Design Review Board Agenda Item Cover Sheet

Meeting Date		Staff Contact
April 5, 2021		Lindsay Kershner
Subject:		
<p>PRE2022-0019: Construction of Millworks Family Housing, a four-story mixed-use building with 83 affordable, one (1) to three (3) bedroom housing units and an 8,300 square foot (sf) childcare center. 56 surface vehicle parking stalls are proposed on the site with access to the parking lot and the site from W. Laurel Street. Additional temporary surface parking is proposed on abutting Port of Bellingham property. The building's floor area is approximately 96,000 sf between the four floors. The proposal also includes installation of street trees and landscaping along W. Laurel Street.</p> <p>Design Review is required because the project is in the Waterfront design review district and the project proponent is requesting four (4) design departures from the design standards.</p>		
Attachments:

Design Review Board (DRB): Staff Report

Project File No: PRE2022-0019

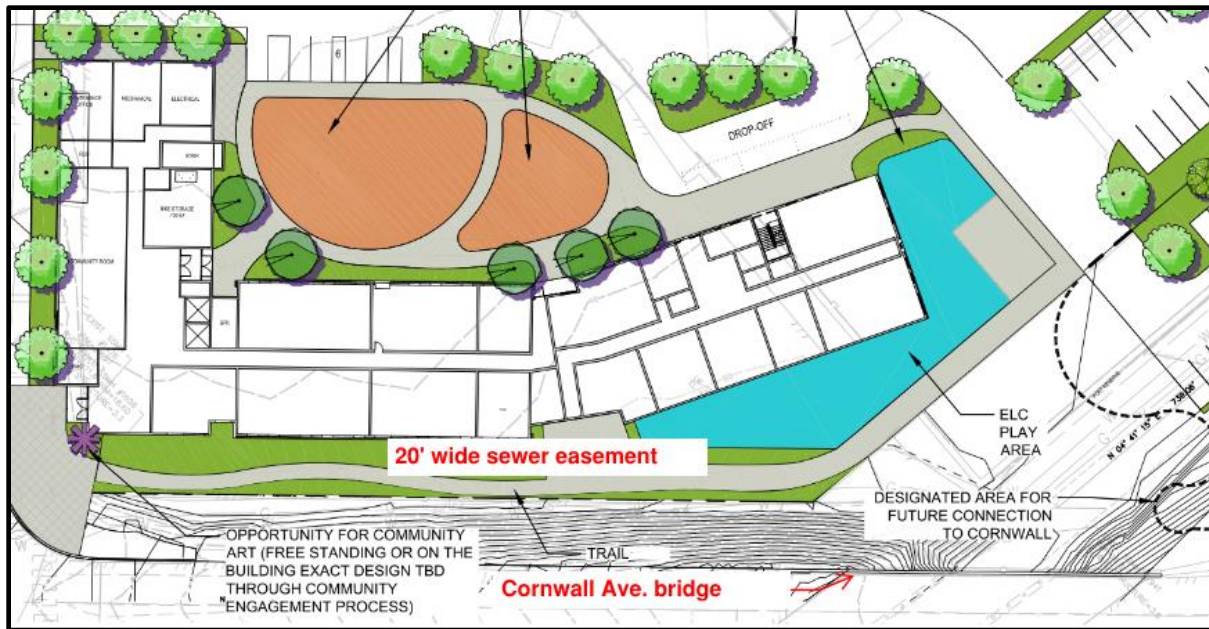
Staff Comment: Staff requests guidance from the Board as to whether the proposed departures from the building not aligning at the Cornwall Ave. property line, not having entrances onto the street every 75 feet, not providing the pedestrian connectivity through the site to Cornwall Ave. currently, meets departure criteria in BMC 20.25.080(B)(1). Given the complexities associated with the sewer main location, steep slope and Cornwall Avenue's future improvements, staff believes that the proposed location of the building, setback from Cornwall Ave. without access to the street from the site, meets the intent of the requirement to the greatest extent practical, if space is allotted on the property for some future pedestrian access to Cornwall Ave. and the 20-foot easement is used for some outdoor activities.

West Laurel Street departure request:

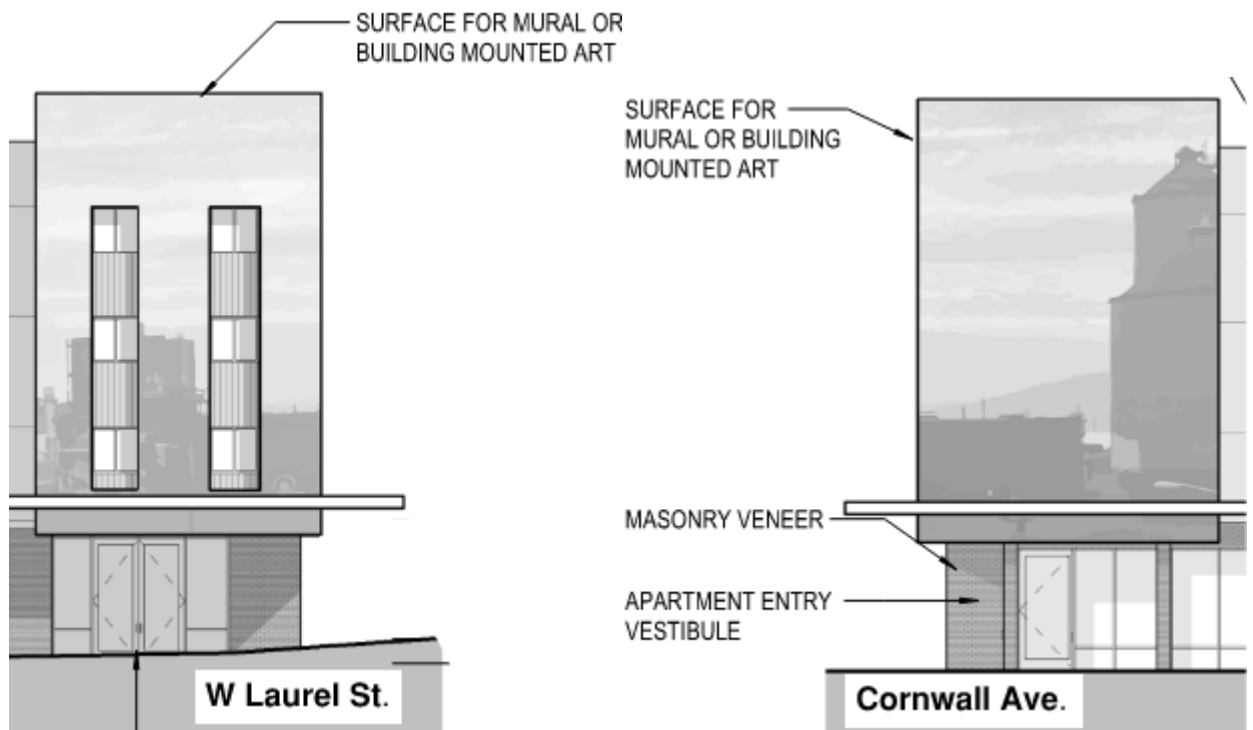
4. **Orientation to Streets, Parks, and Trails, BMC 20.25.080(C)(1)(a)(iv):** Commercial buildings facing public streets or trails in commercial mixed-use areas shall have entrances from the street or trail every 75 feet, on average.

Staff Comment: Staff requests guidance from the Board as to whether an additional entrance to the building is necessary along W. Laurel St. or if the proposed single entrance at the corner of W. Laurel St. and Cornwall Ave. is sufficient and can be found to meet the departure criteria in BMC 20.25.080(B)(2). The intent of the Orientation standard is to, "Reinforce pedestrian activity, orientation to ground floor activities and enhance the liveliness of the street and public spaces through building location and design." The length of the building wall along W. Laurel St. is approximately 140 feet, which establishes the requirement for two entrances. Staff believes that having an emphasized primary entrance at the corner of W. Laurel and Cornwall Ave. provides a strong entrance to the Waterfront district and the building itself. Given the use of the building, the applicant wants to control access to the building and only have one entrance. Staff is seeking guidance from the board on whether another entrance should be provided along W. Laurel St. or if having a single entrance meets the departure criteria.

Cornwall Avenue - Art Wall

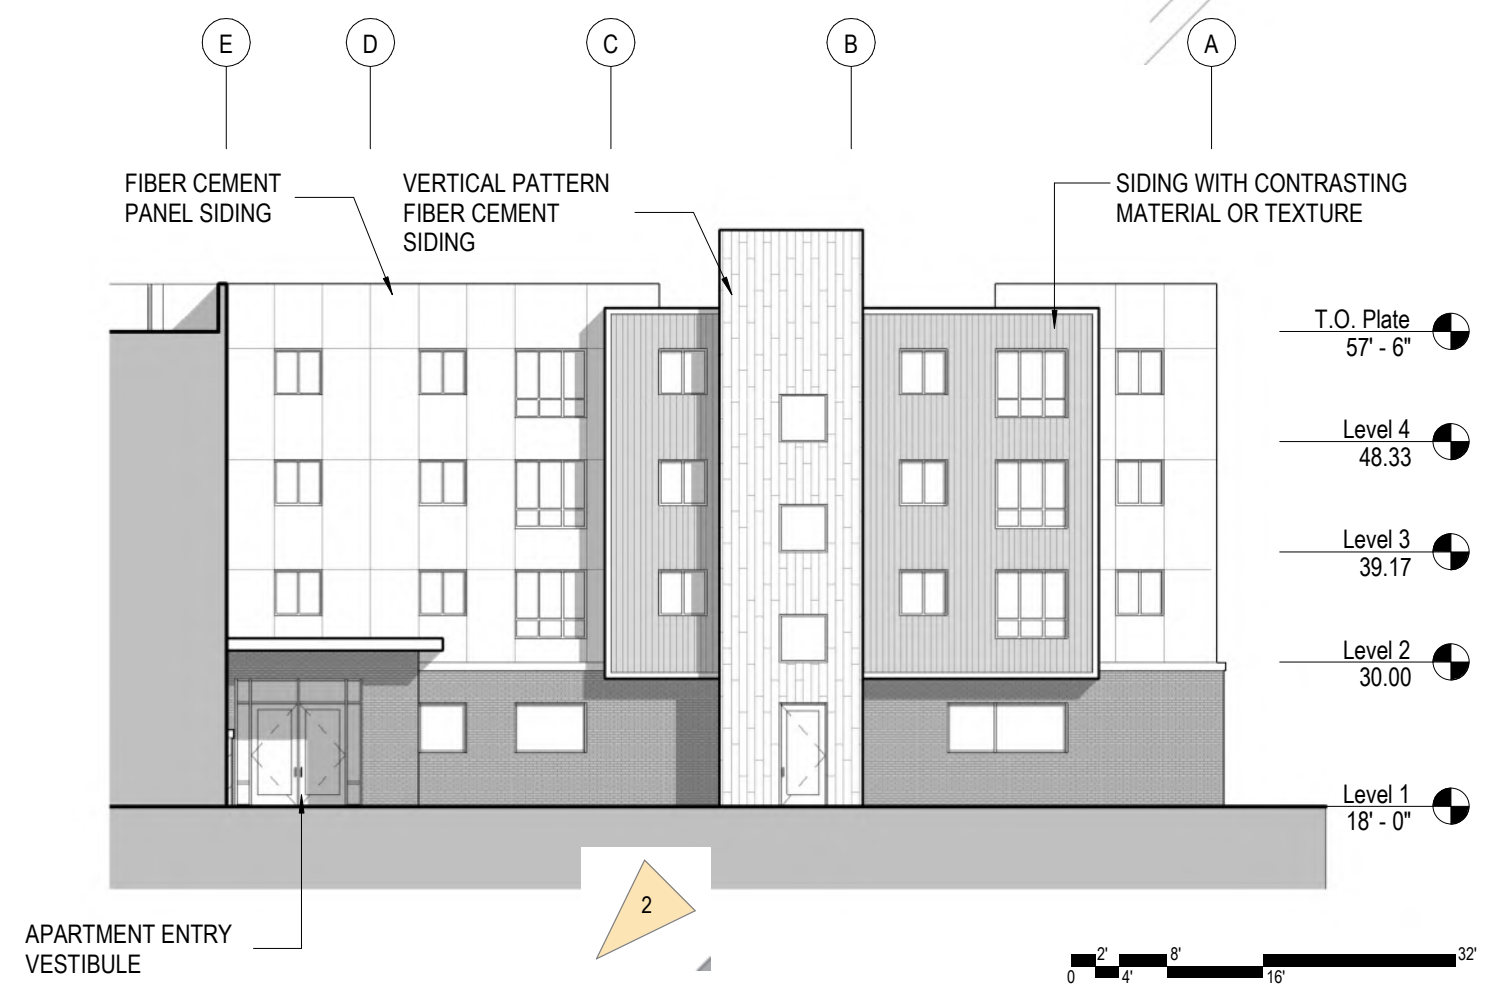
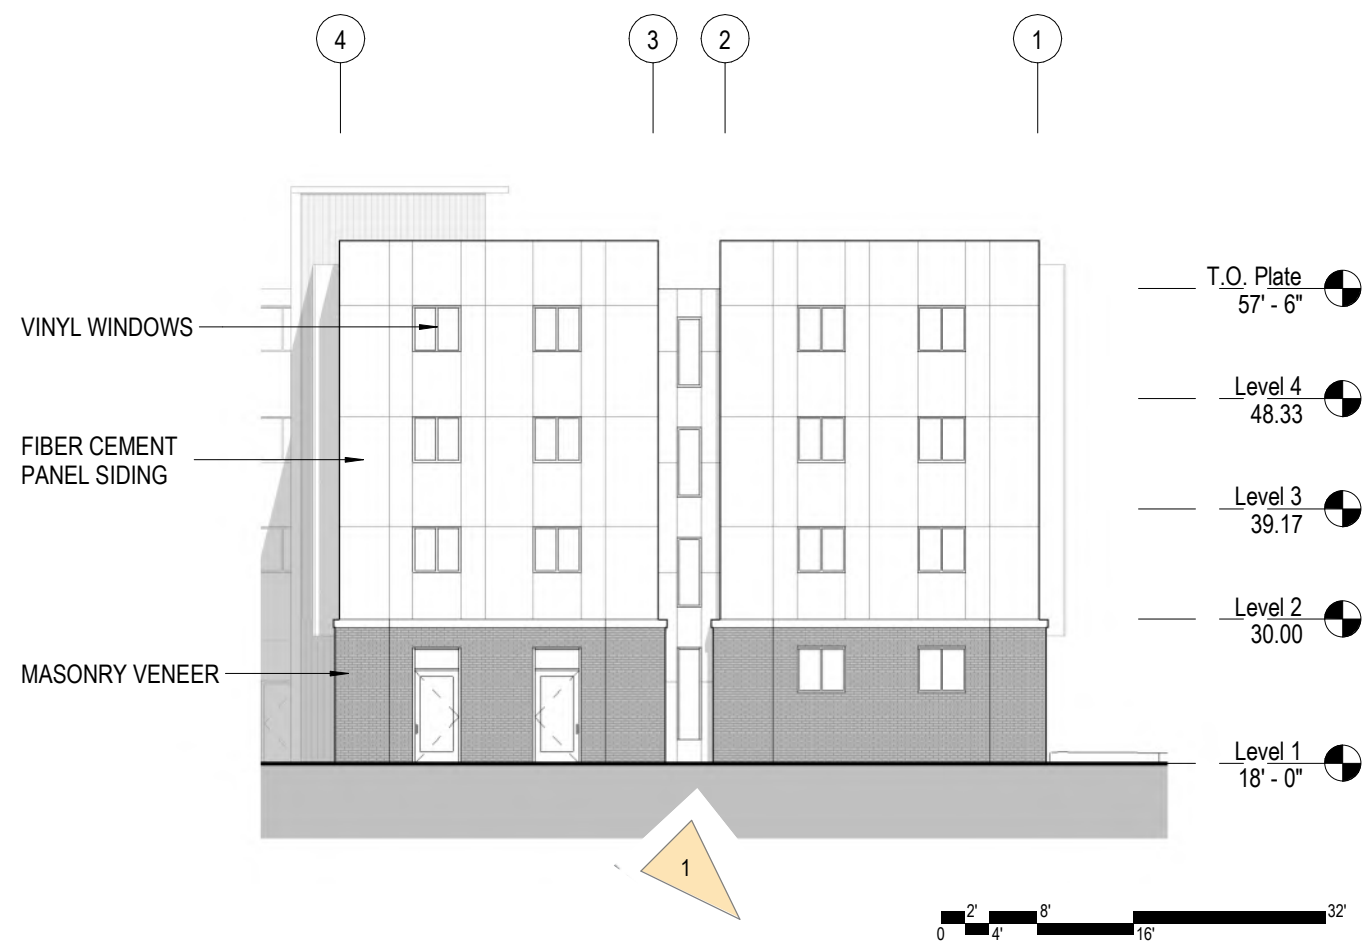
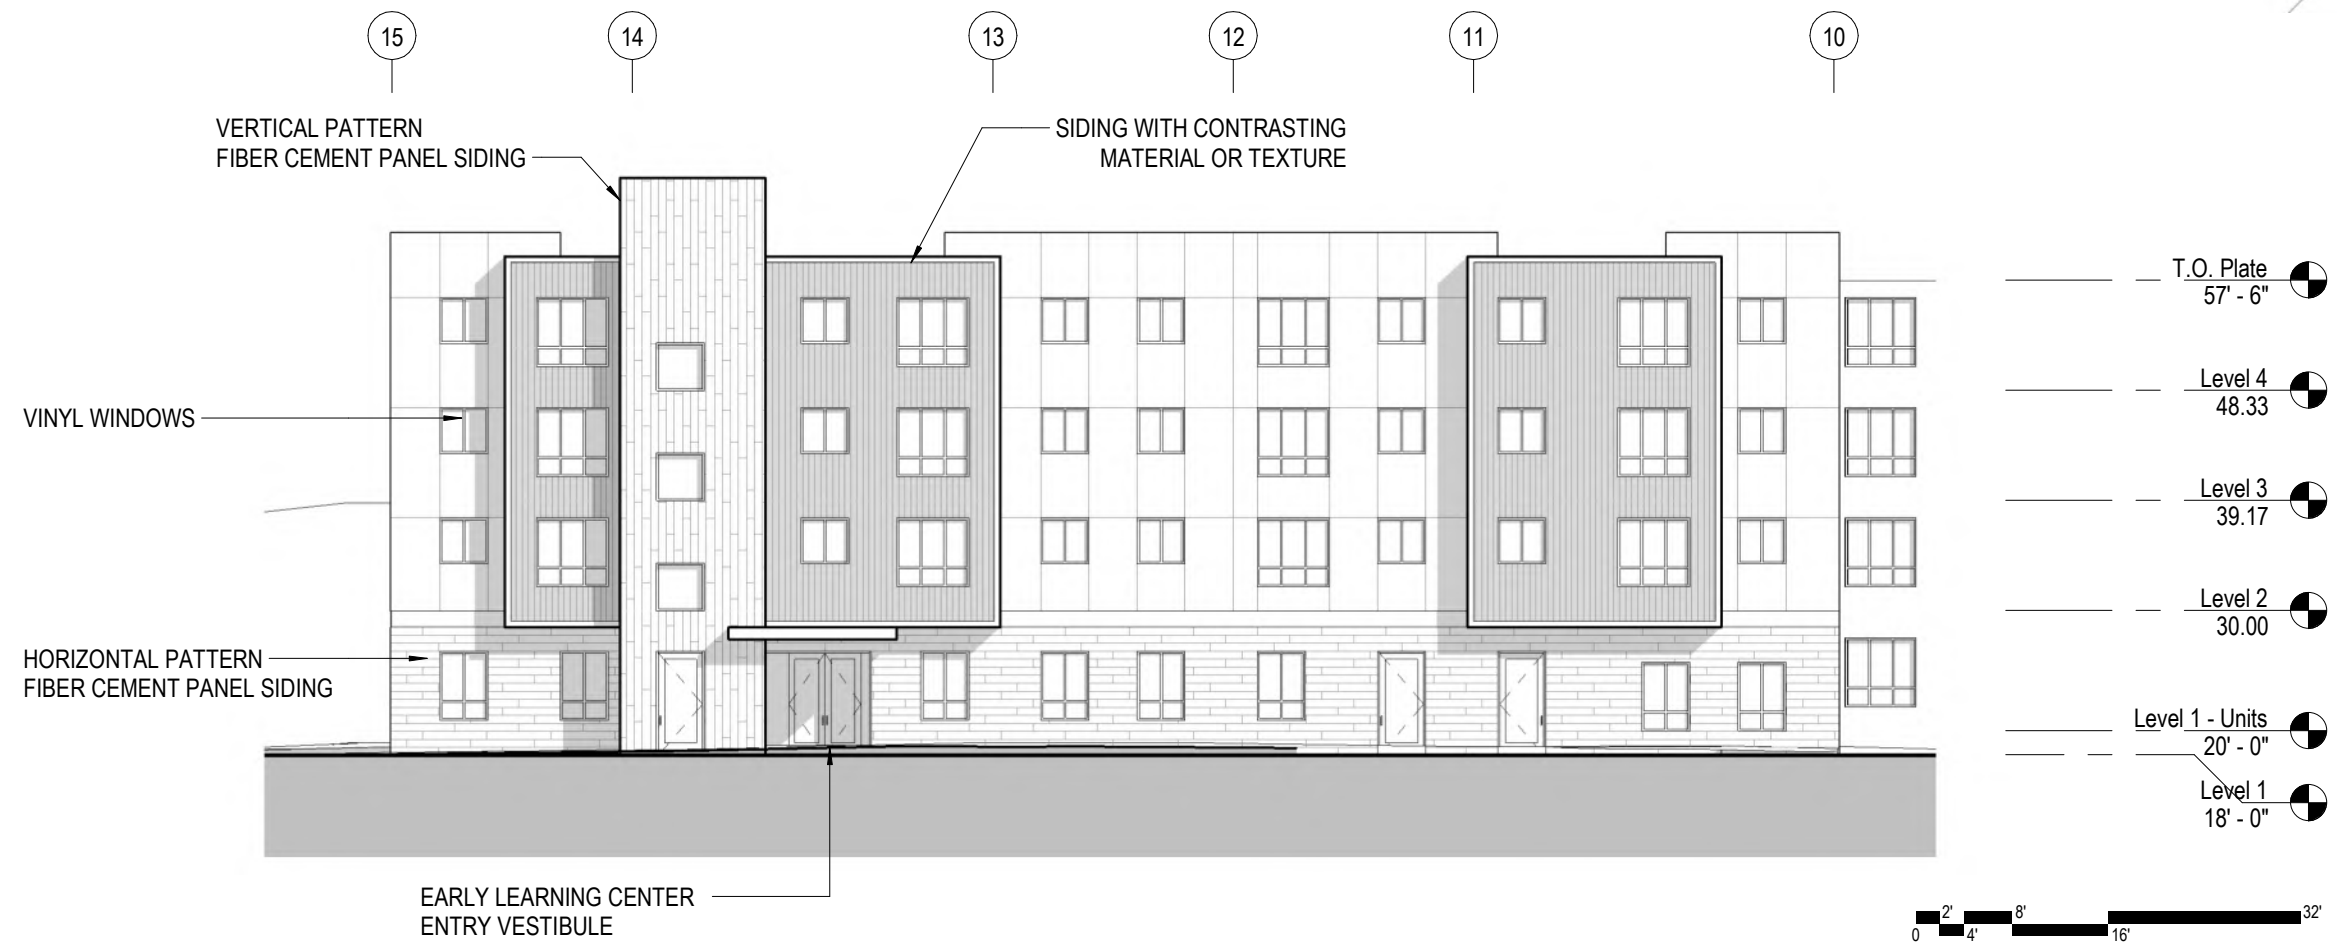
Staff Comment: Staff requests guidance from the Board regarding the proposed artwork on the southwest corner of the building. This is the main entrance to the building and, as the architect stated in their response to the design criteria, a gateway to the Waterfront district.
